Technical BULLETIN

RECALL

2002 XV1700PCP, PCPC FACTORY MODIFICATION CAMPAIGN

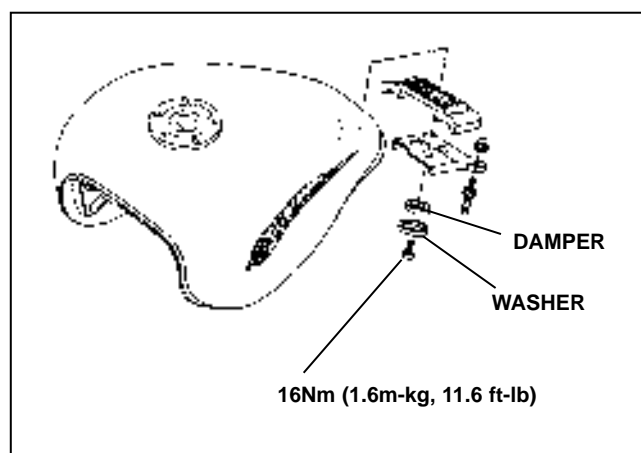
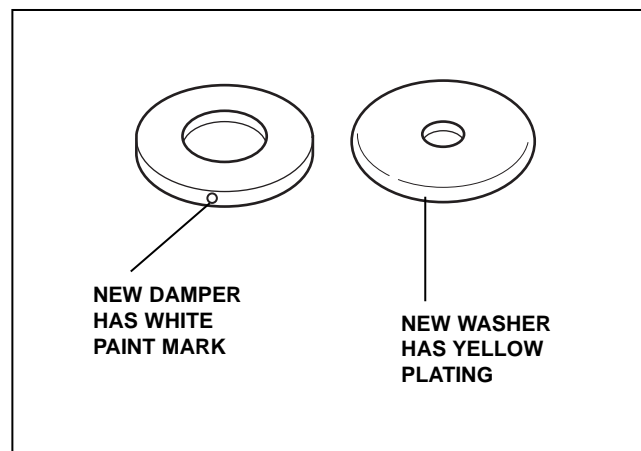
Yamaha Motor Corporation, USA has determined that a defect which relates to motor vehicle safety exists in 2002 XV1700PCP and XV1700PCPC ("Road Star Warrior") motorcycles. In affected motorcycles, the fuel tank bracket washer and damper do not adequately protect the tank from engine vibration. Over a period of time, vibration might damage the tank which could result in a fuel leak with the possibility of fire.

2. Replace the original fuel tank bracket washer and damper with the modified ones.

To correct this defect, Yamaha is initiating a Factory Modification Campaign. Affected motorcycles must have the fuel tank bracket washer and damper replaced with ones of a new type.

⚠ WARNING

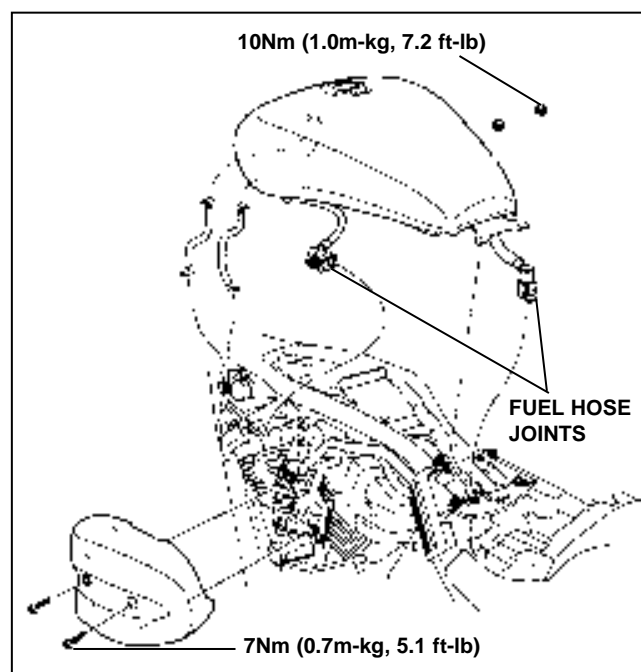
Be sure the two fuel hose joints are connected securely.

IDENTIFICATION PROCEDURE

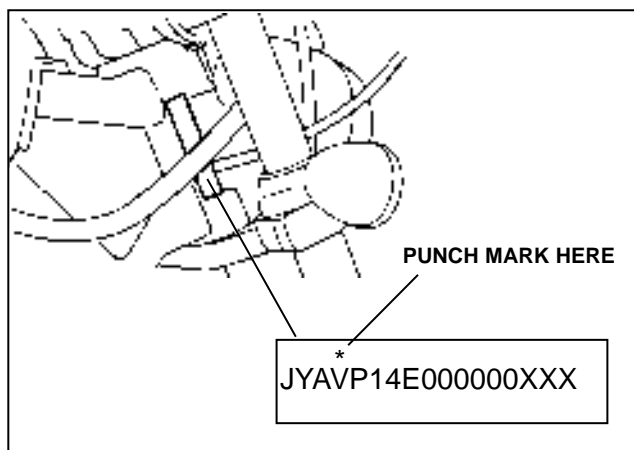
After modifying a unit, make a punch mark above the frame number (VIN) on the steering head pipe as shown in the adjacent illustration.
